PLAN COMMISSION

October 9, 2018

PLAN COMMISSION REPORT

C1 - Concept Site Plan (1 page)

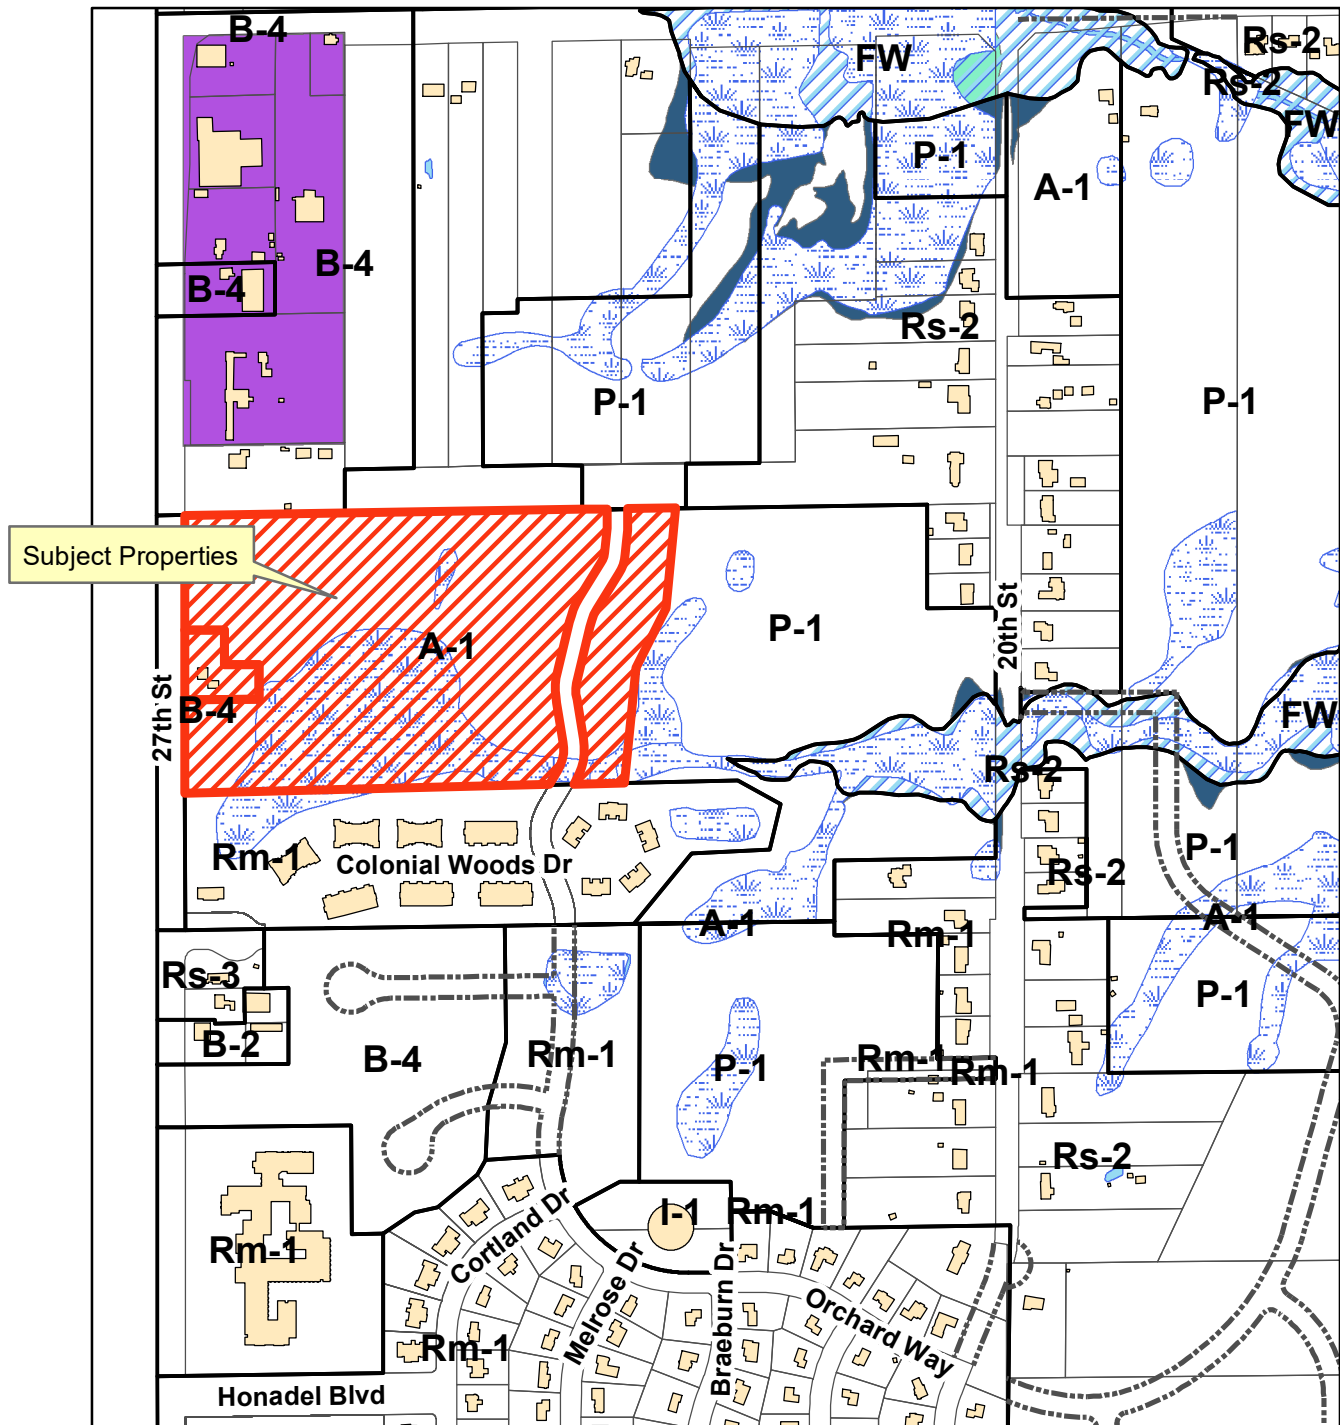
- Due to the proposed density – 294 units in 27-unit, 33-unit, and 48-unit buildings on approximately 17 non-wetland acres - a Conditional Use Permit or Planned Unit Development will be required. It should be noted that a modification to the minimum lot area per unit will be required.

- For Plan Commission reference, the recently-approved Orchard Hills multifamily residential development south of this and the Colonial Woods development included 225 units on approximately 17 non-wetland acres. A maximum of 20 units per building was approved.

- Falk Park exists to the north and east of the proposed development. Previous plans included a required tree preservation buffer along the east property line, and may be required for this development as well. Instead of integrating this development into the park, the concept shows a large detention basin that essentially serves as a barrier between this residential neighborhood and the park.

- The concept plan maximizes the unit count and density on the site, but sacrifices design elements that are essential to long term sustainability of mixed residential neighborhoods, such as designed open space, pedestrian amenities and connectivity.

TOTAL PROPERTY = 10.83 AC	
TOTAL UNITS	192
TOTAL UNDERGROUND PARKING	192
TOTAL DETACHED GARAGE PARKING	44
TOTAL SURFACE PARKING	162
TOTAL PARKING	403

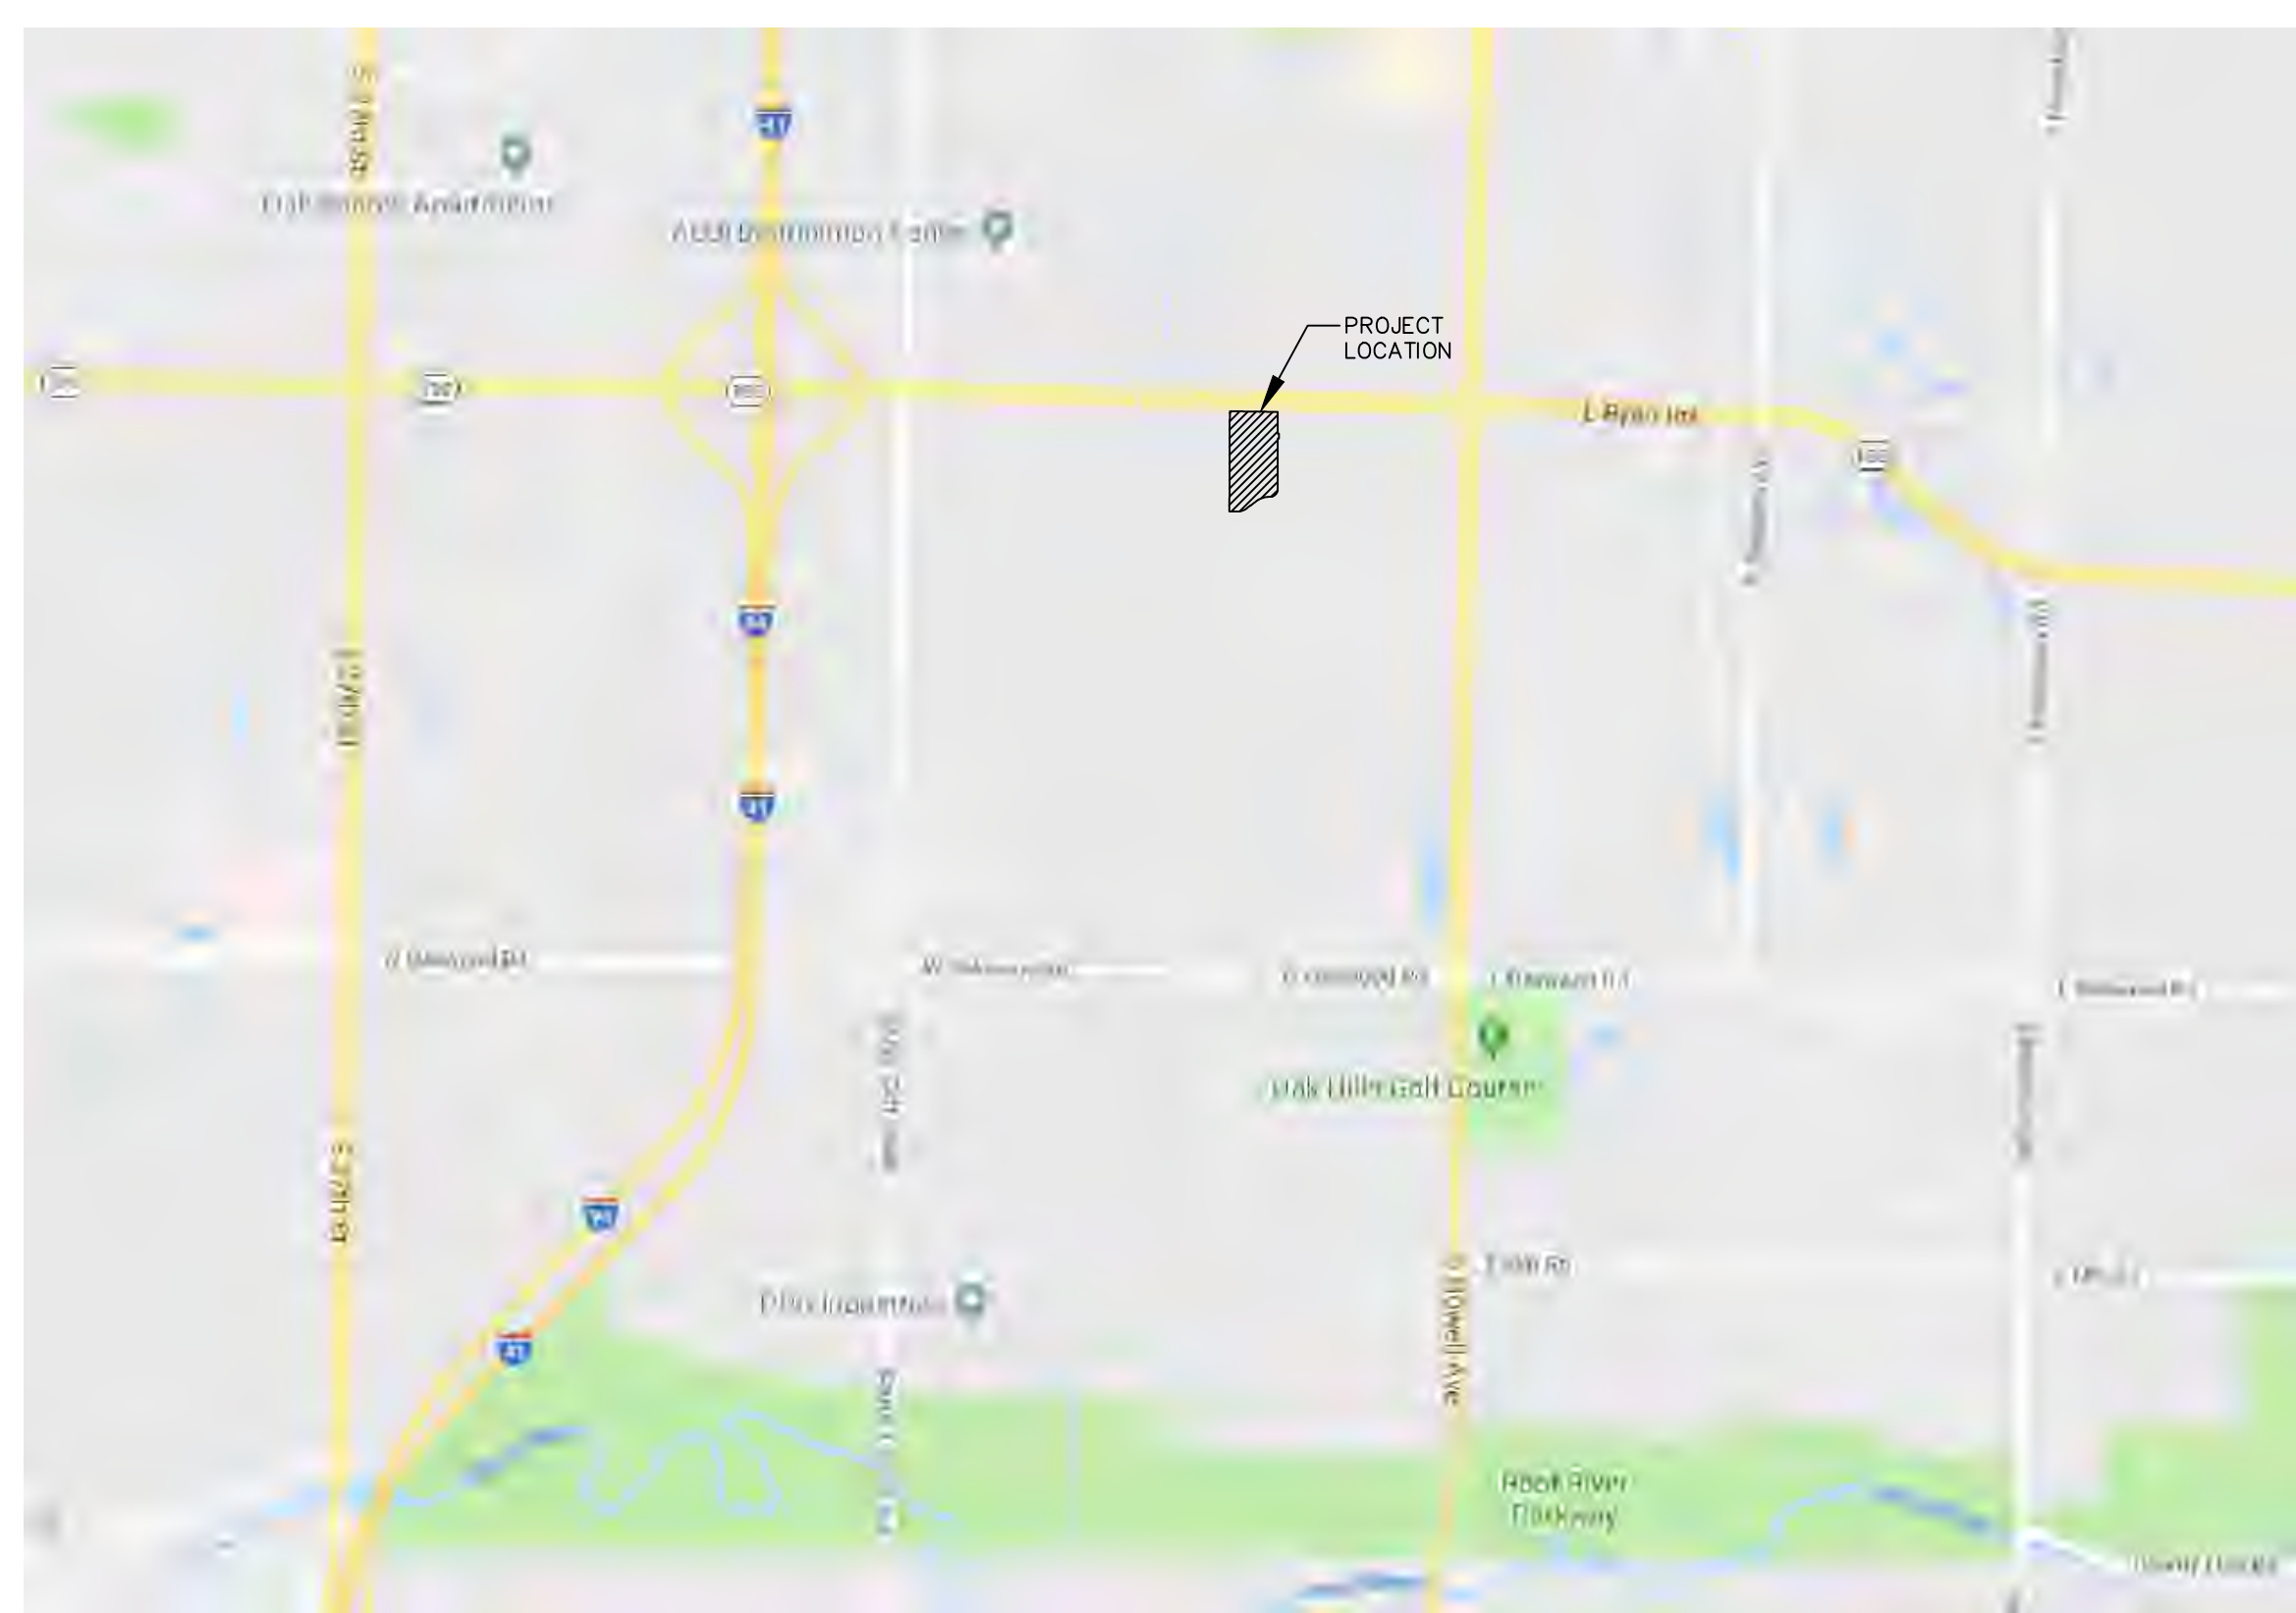
- The future land use map adopted as part of the Comprehensive Plan illustrates this area as Planned Industrial. Both a Comprehensive Plan Amendment and rezone for a multifamily residential development would be required.

- Due to the proposed density – 192 units in 30-unit and 33-unit buildings on approximately 11 gross acres (18 units/acre) - a Conditional Use Permit or Planned Unit Development will be required. It should be noted that the proposed density is in excess of what is allowed per Code for the mix of units, and a modification to the minimum lot area per unit will be required.

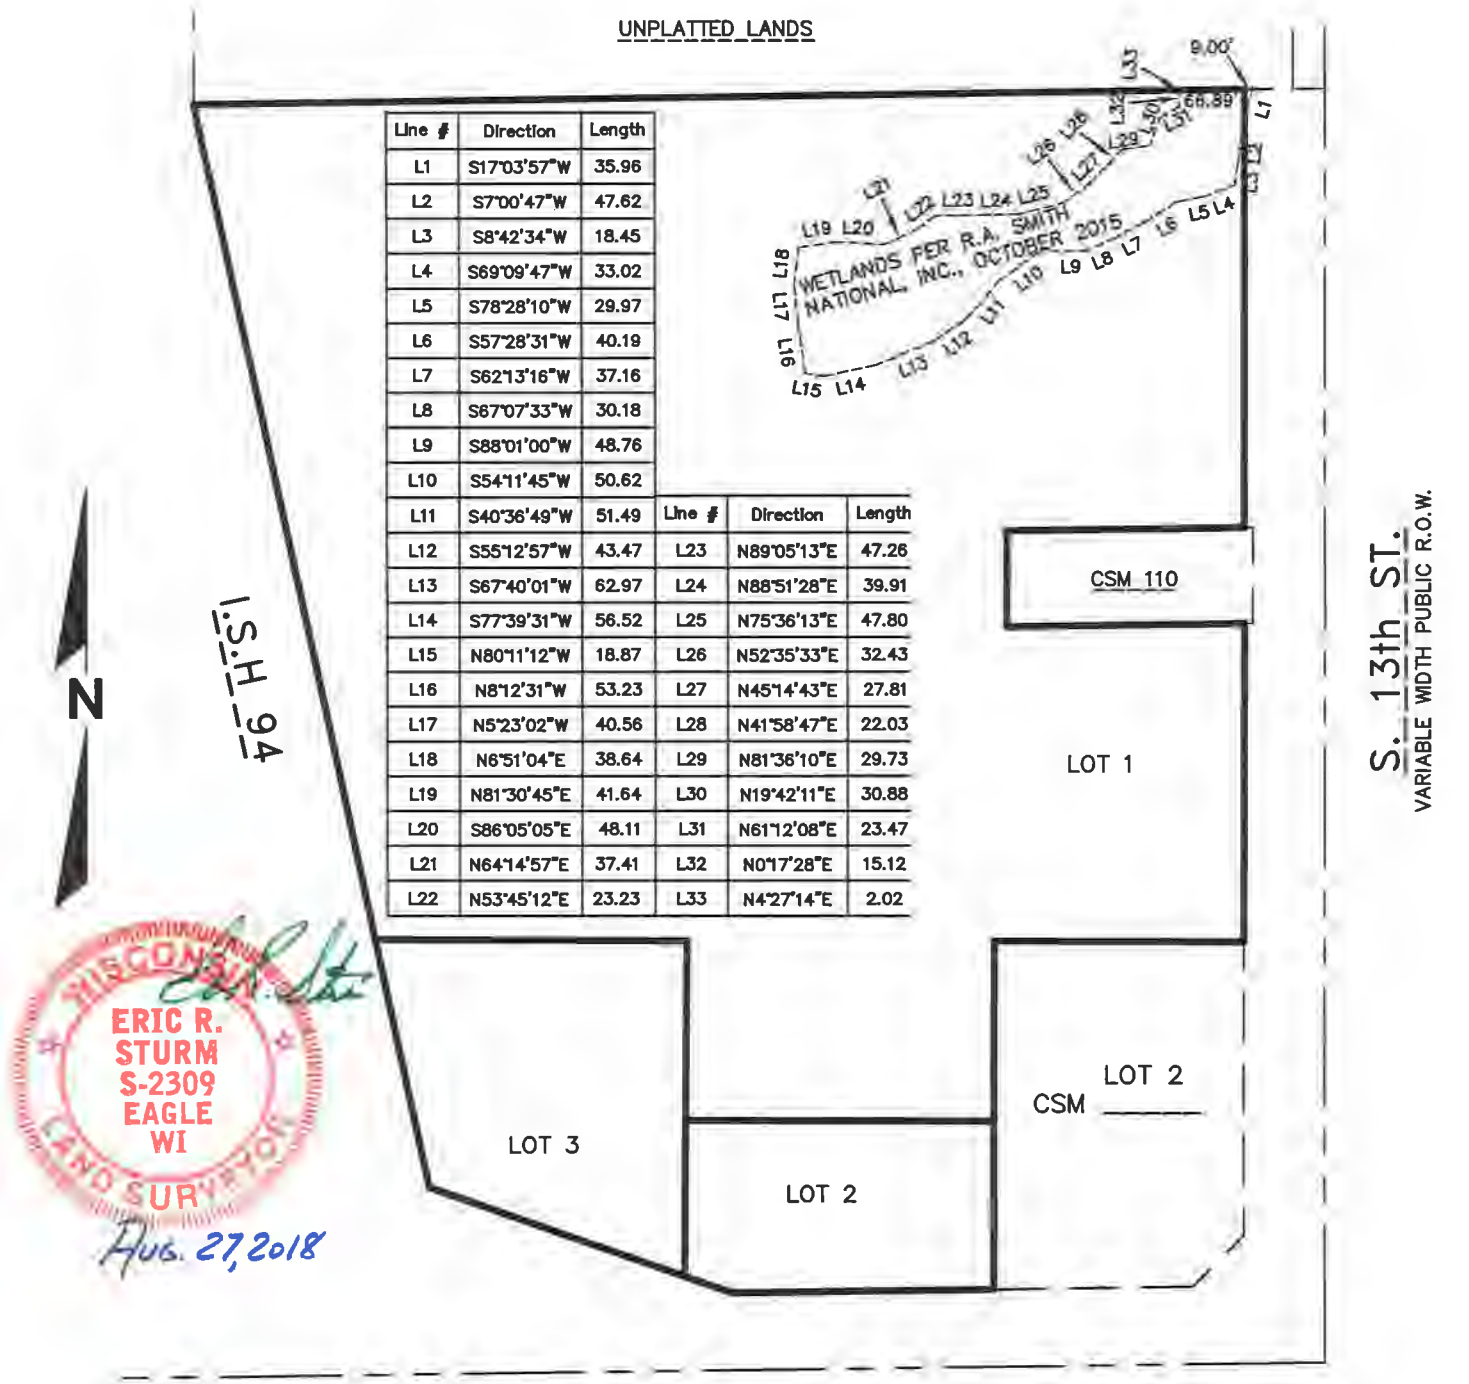
Wetlands have been delineated and are shown on the northeast side of Lot 1 on Sheet 2. However, wetlands should be shown on all pages of the CSM prior to recording, and a condition of approval for such is recommended above.

EXHIBIT A: CONCEPT SITE PLAN (ENLARGED)

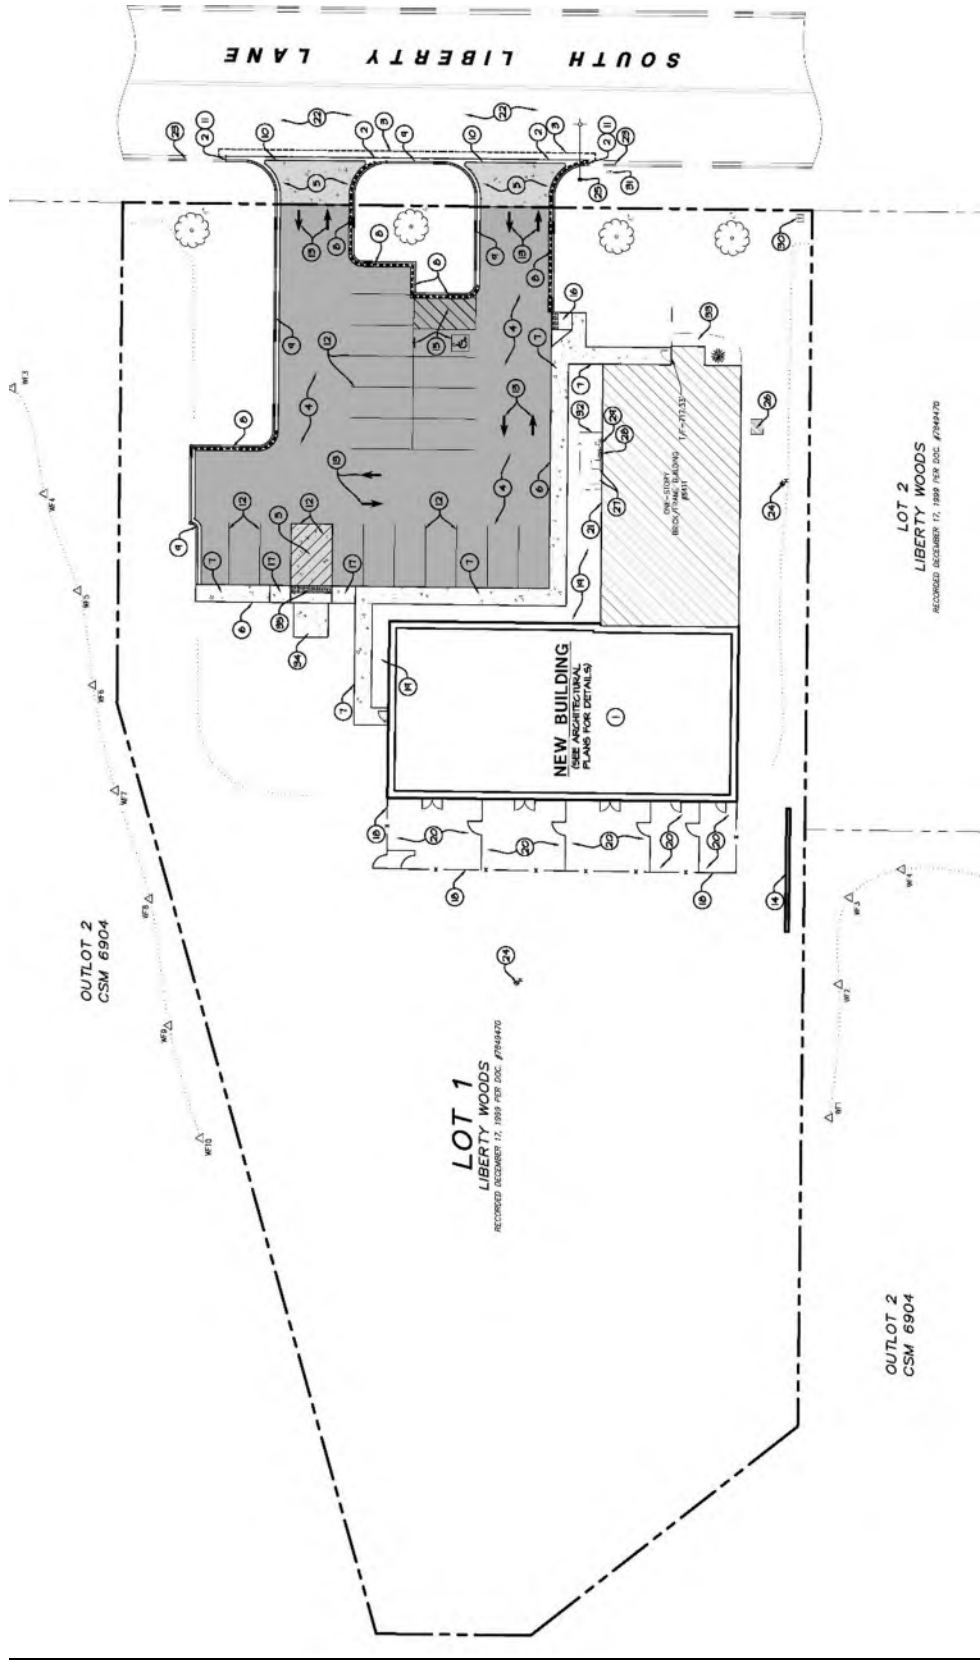
Current plans show that the addition is approximately ½-inch shy of the required setback (20 feet) on the south side of the building. Staff notes that the proposed addition is in line with the existing building, which was constructed in 2006. It is likely that the measurements for the existing building were not as precise as what is being shown today. It is not practical from a construction standpoint to set the addition back by ½ inch; therefore, staff is recommending approval of the plan as proposed.

Parking for 17 vehicles (according to the original approved plans) exists on the property north of the existing building. The plans propose to reconfigure and expand the parking to a total of 20 stalls. Part of the expansion requires the reduction of the existing landscape island separating the two driveways. However, the modification to the landscape island leaves the easternmost parking stall less than the required setback to the right-of-way. Per the Conditions and Restrictions, parking is required to be at least 40 feet from the right-of-way. This must be corrected in revised plans.
